**PLANNING AND ZONING COMMISSION MEETING**

Tuesday, November 9, 2021, at 4:30 PM  
191 5<sup>th</sup> Street West, Ketchum, Idaho

5. ACTION - Recommendation to approve the 380 N 1st Ave Mixed-Use Building Design Review (Application File No. P21-085).

**STAFF REPORT  
KETCHUM PLANNING AND ZONING COMMISSION  
MEETING OF NOVEMBER 9, 2021**

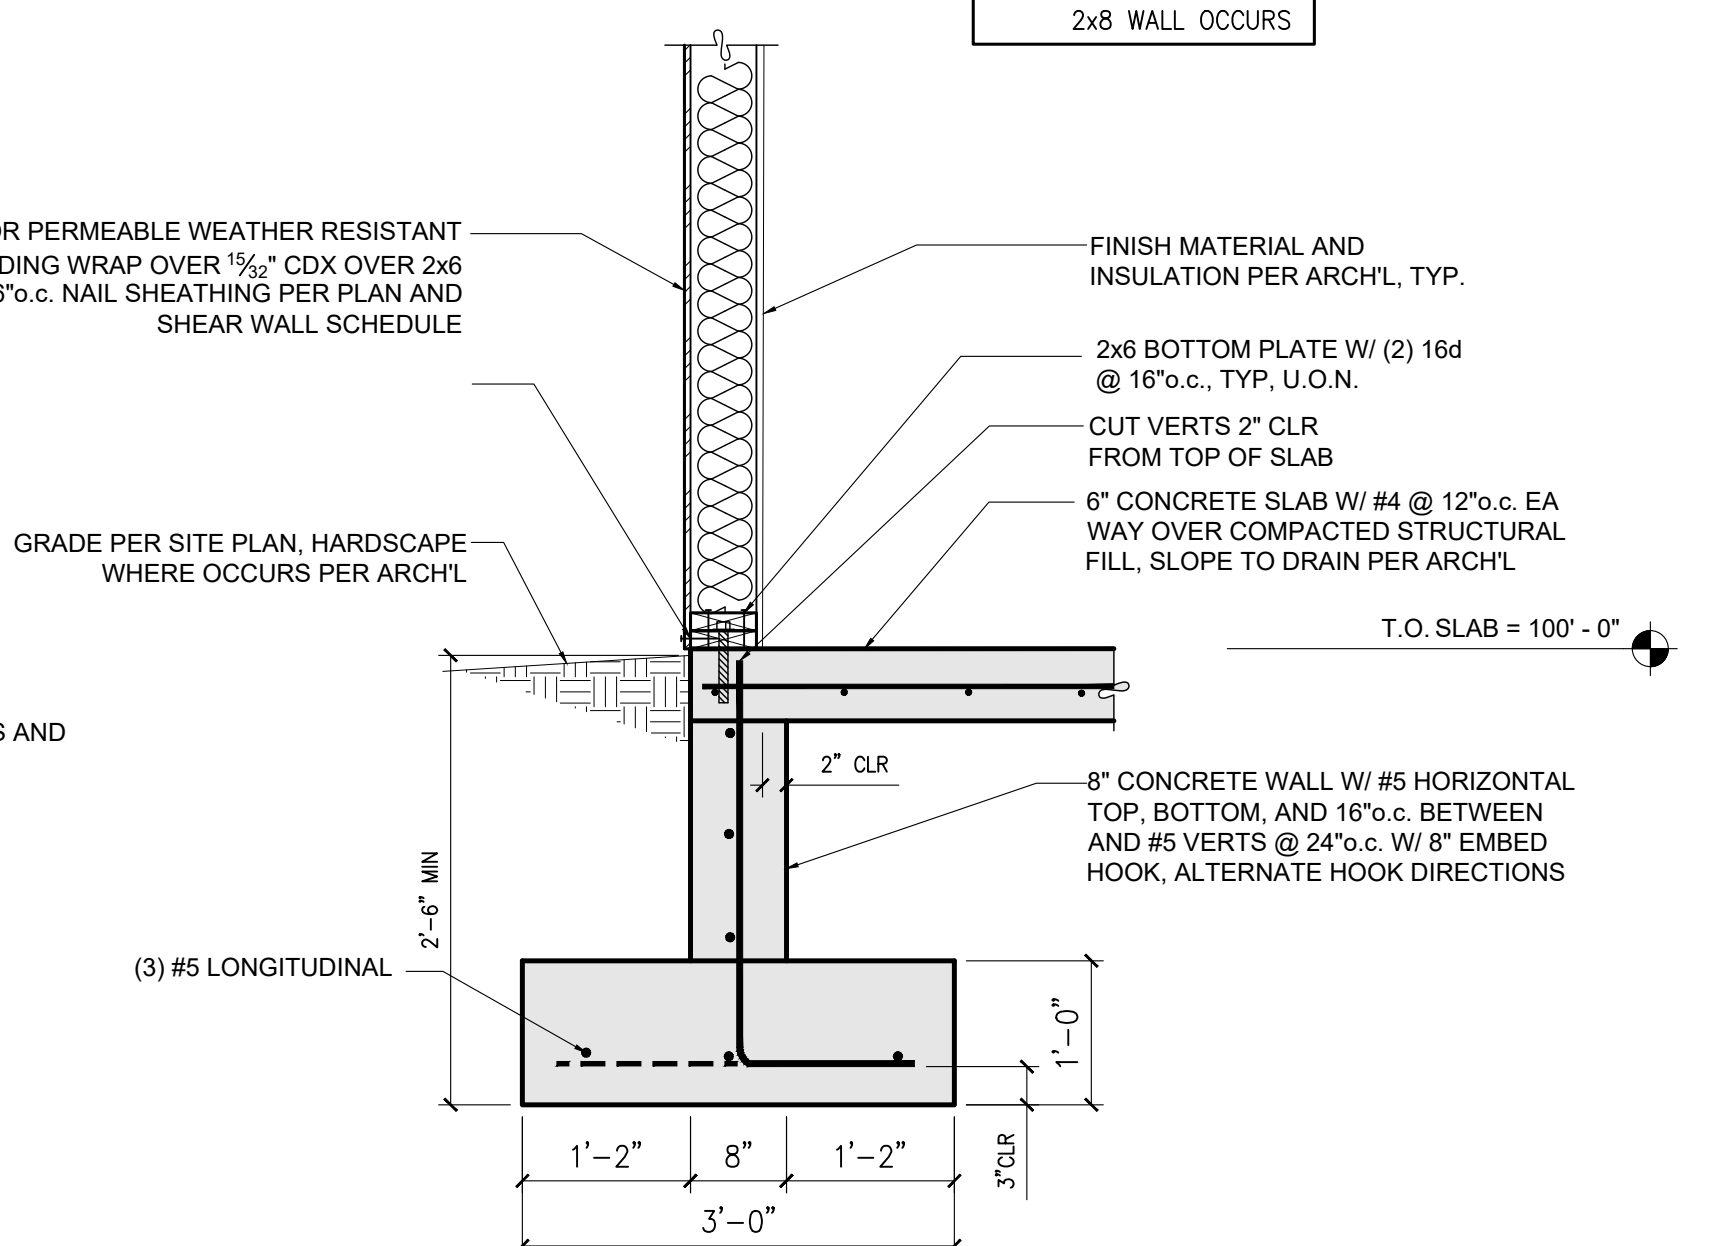
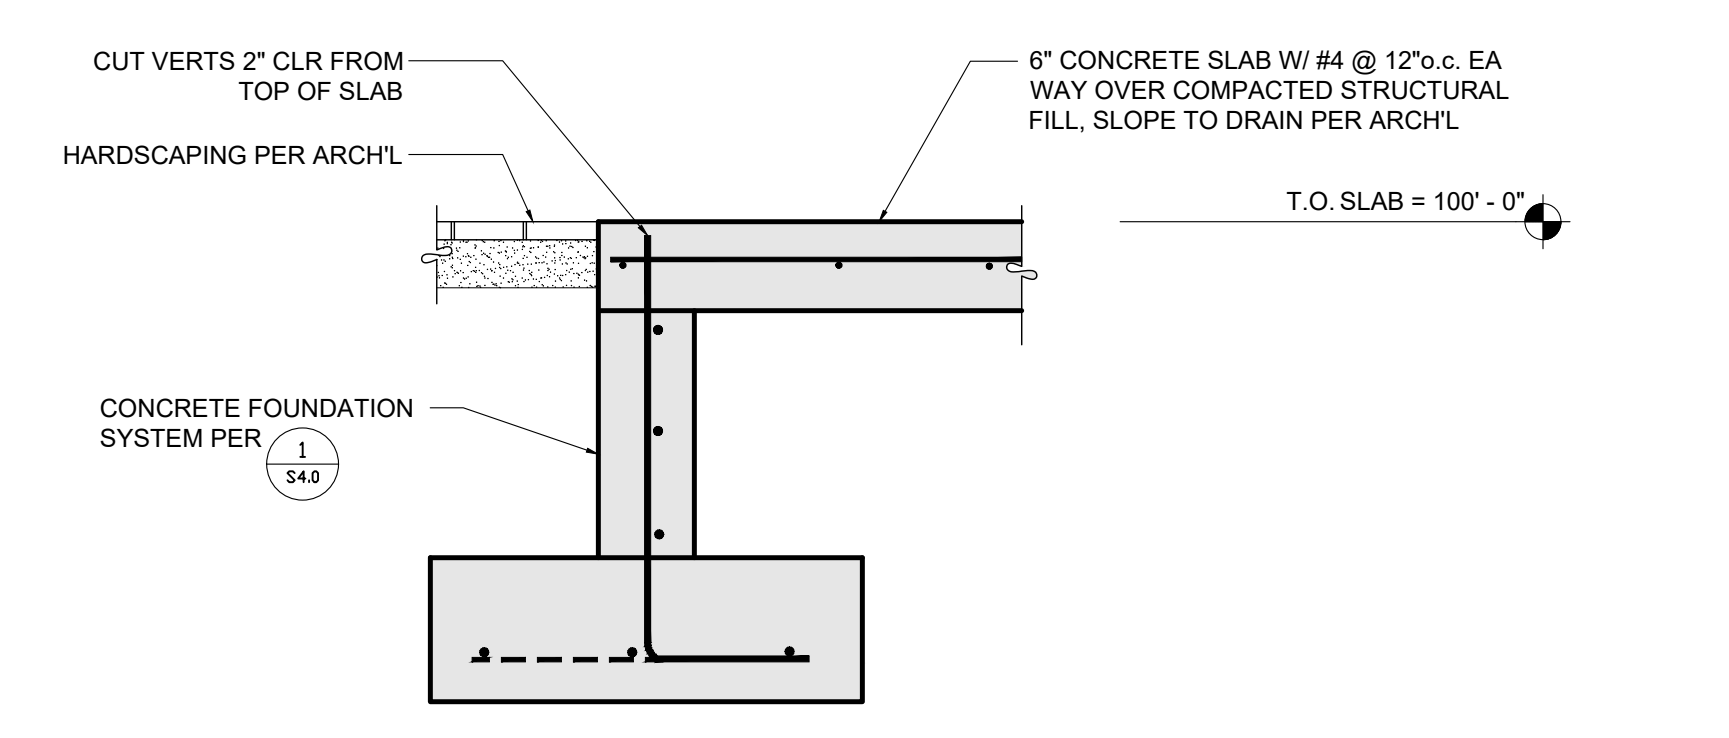
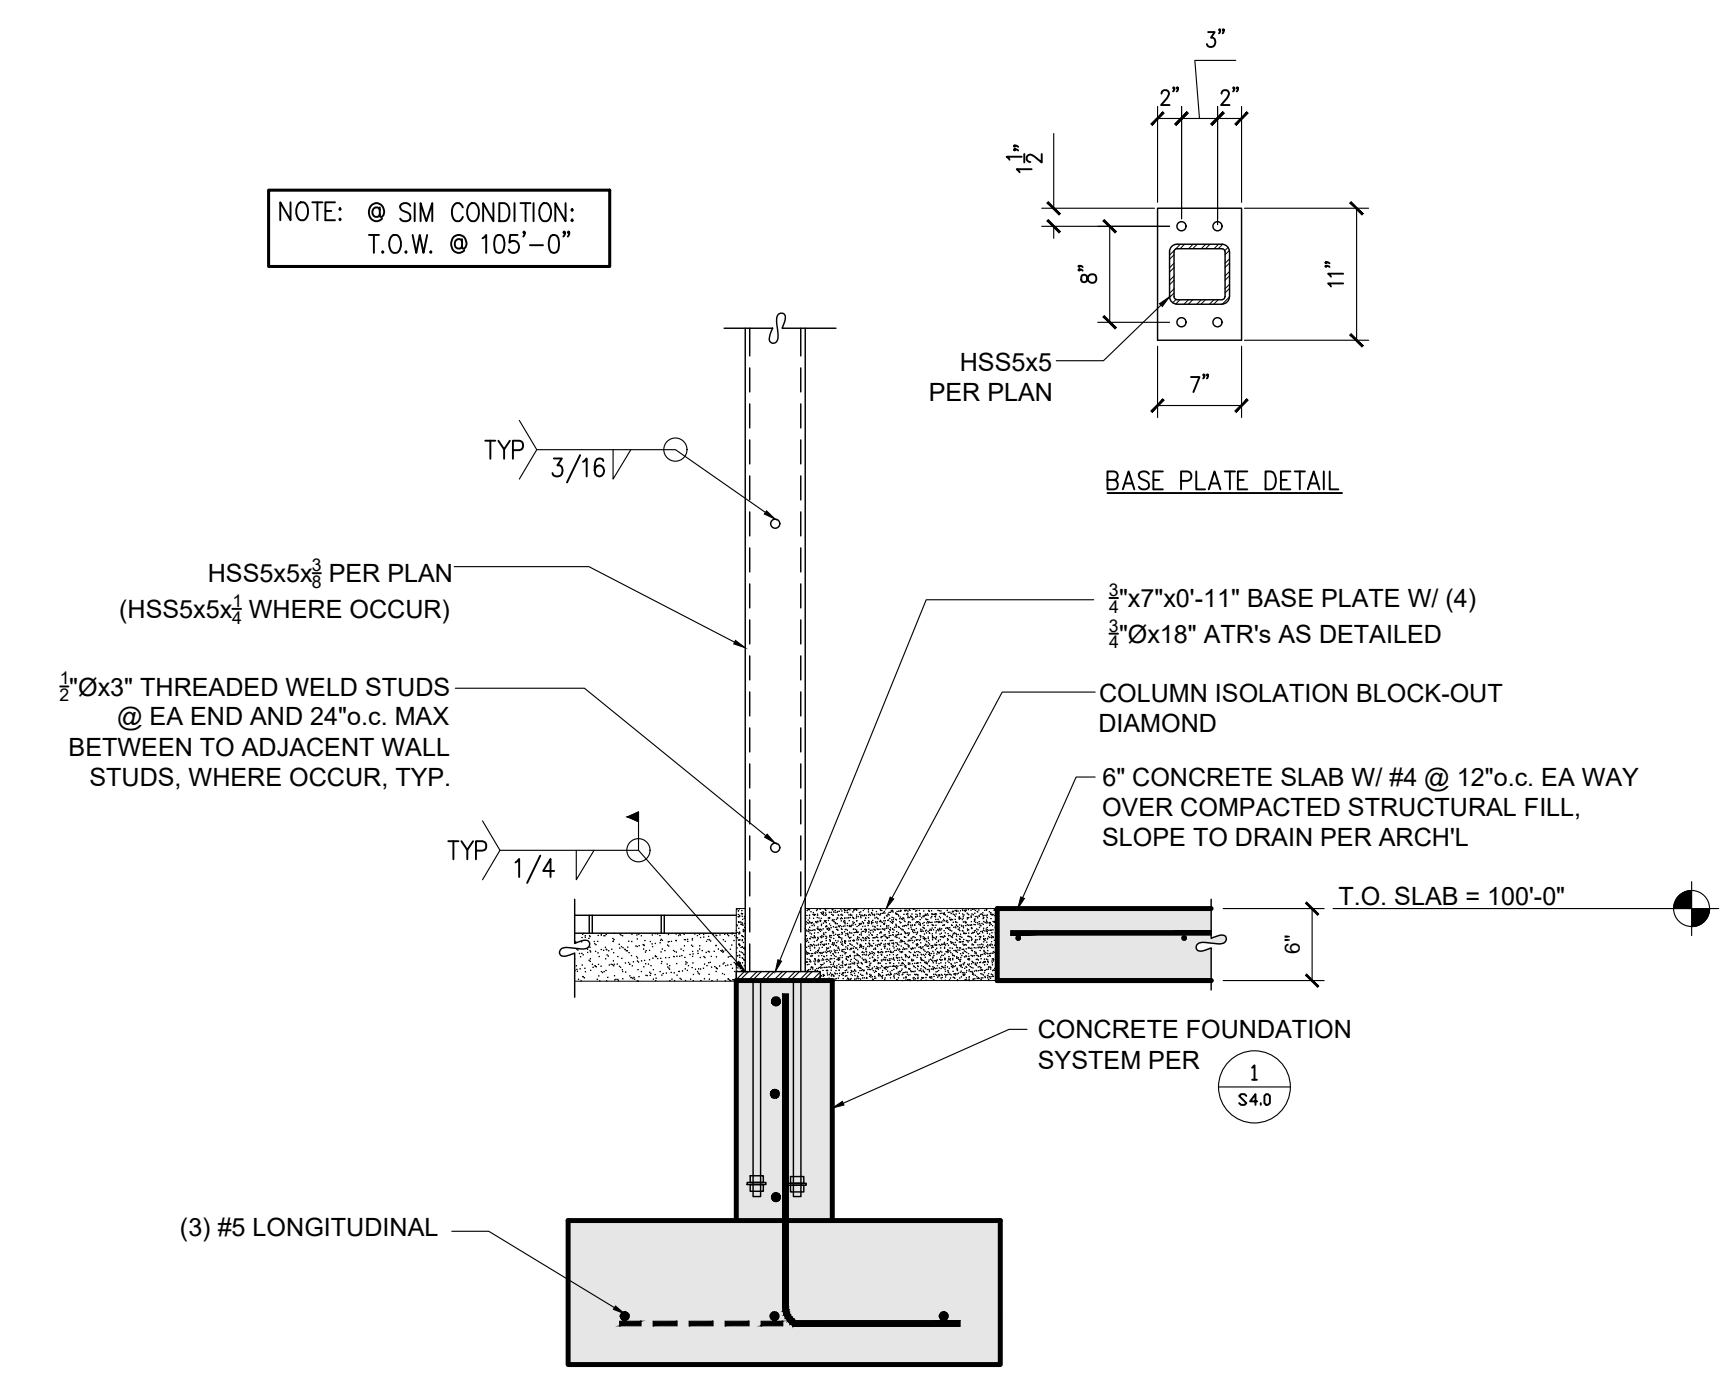
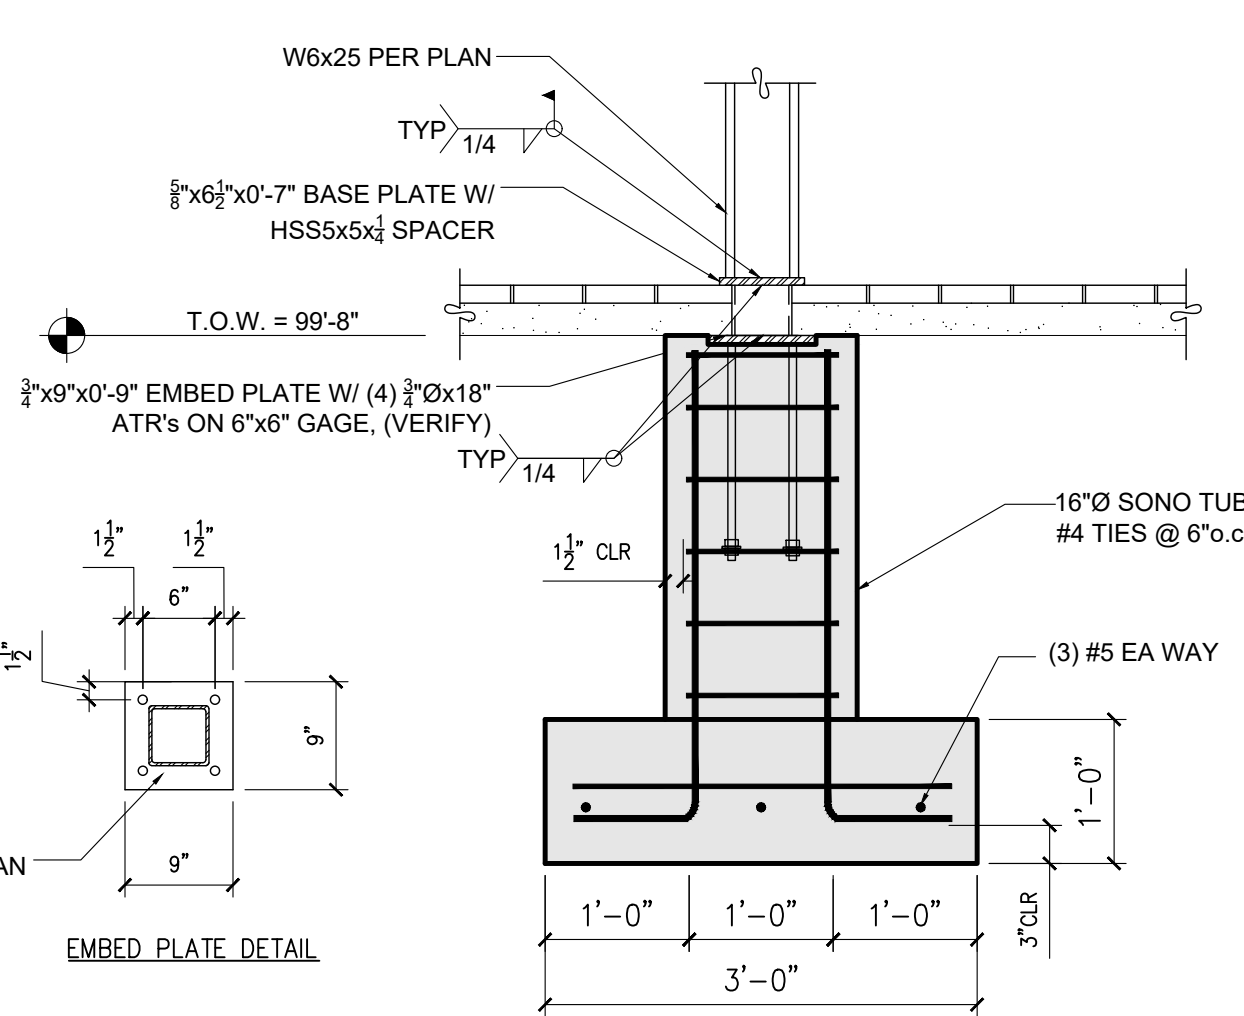
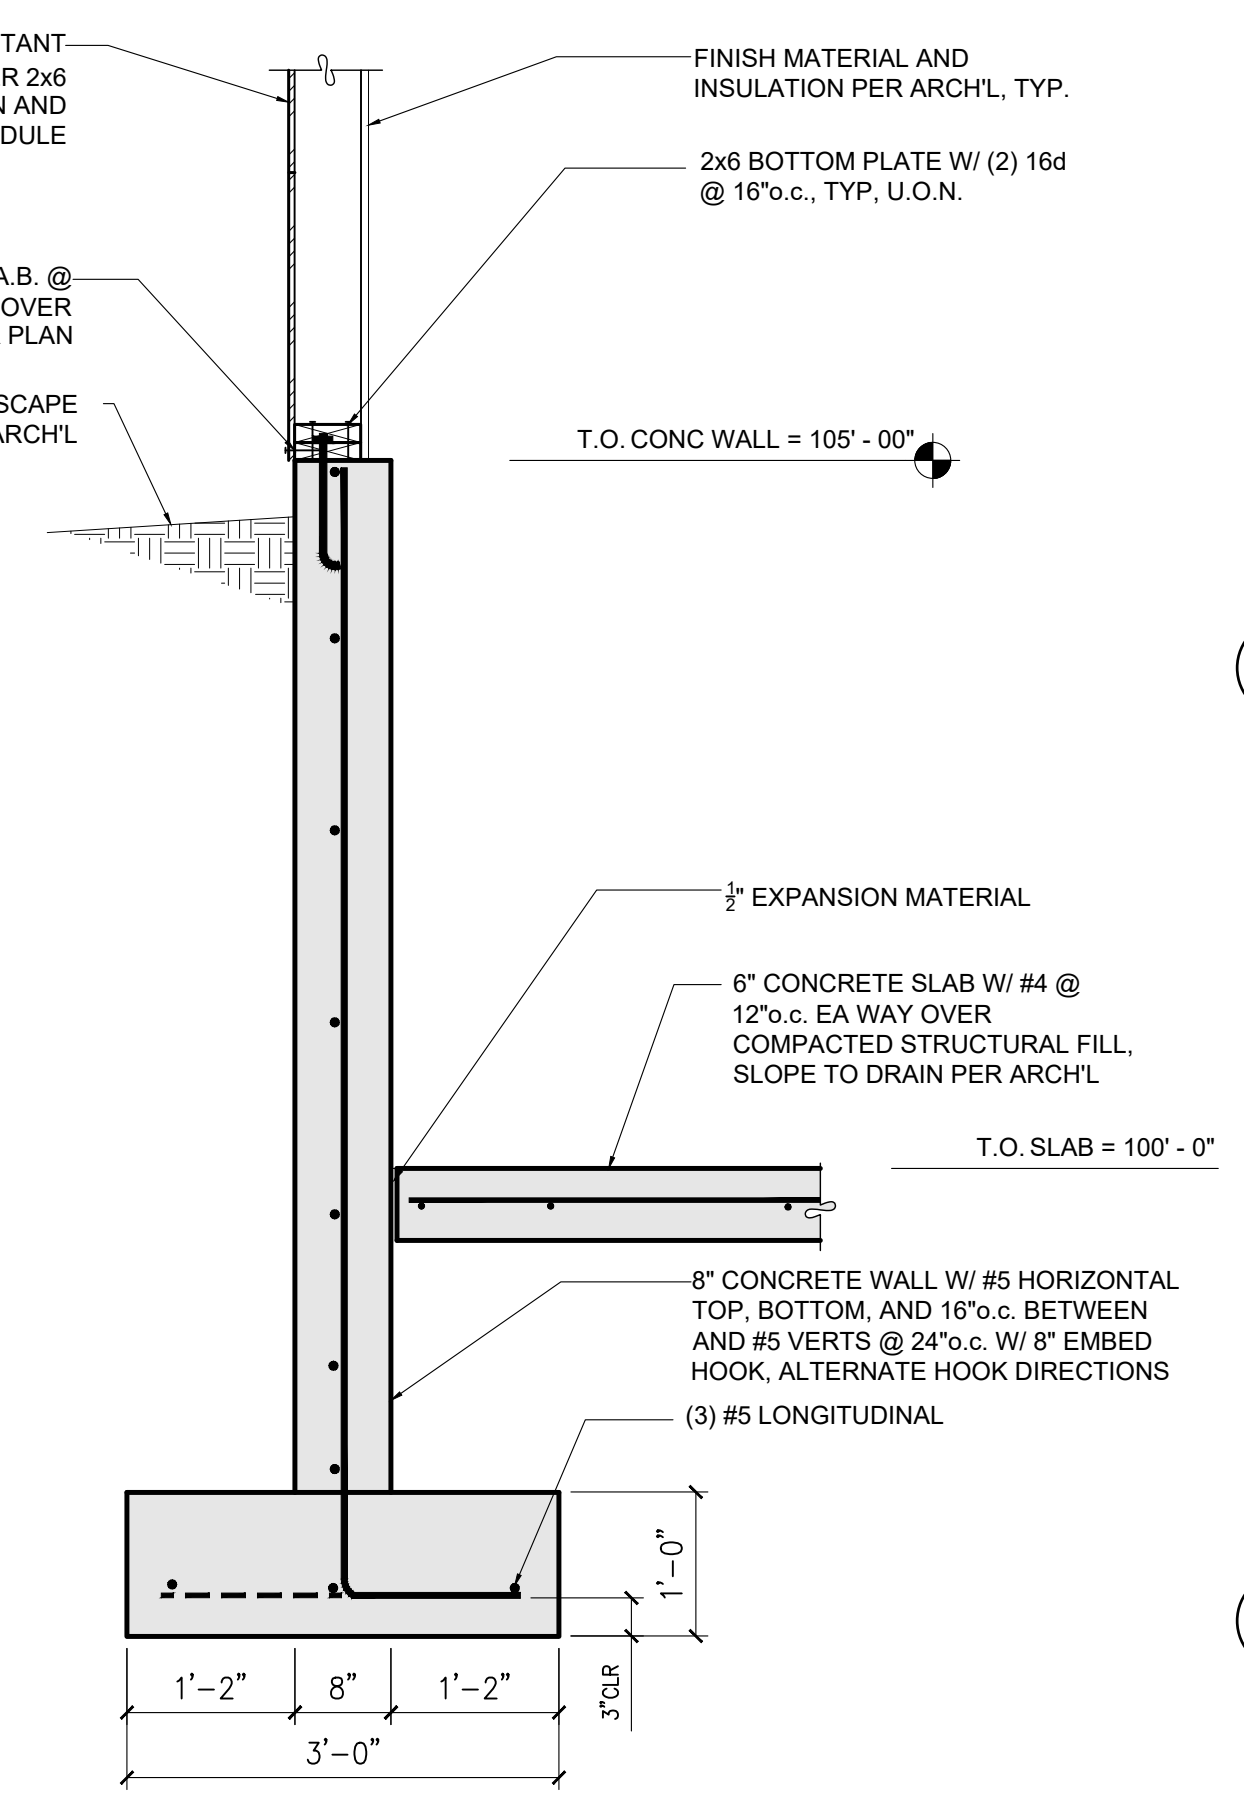
The structural details on Sheet S4.1 show that the concrete wall is 9 feet-2 inches in height from the bottom of the footing to the top of the wall. As noted in the applicant's letter (Exhibit A), the wall has been engineered to withstand the avalanche forces that may impact the property. The foundation plan on Sheet S2.0 (See Figure 2) shows that the avalanche wall and building foundation footings are connected.
